## **Product Change Notice (PCN)**

PCN Number: PCN-0374346R-01

Product(s) Affected: CST-931AP

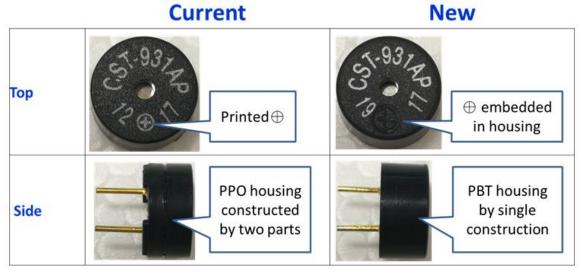
Description of Change: Housing changing from two pieces (top+bottom) to one single plastic piece, plastic changing to higher temperature PBR material, positive terminal marking embedded into housing instead of printed.
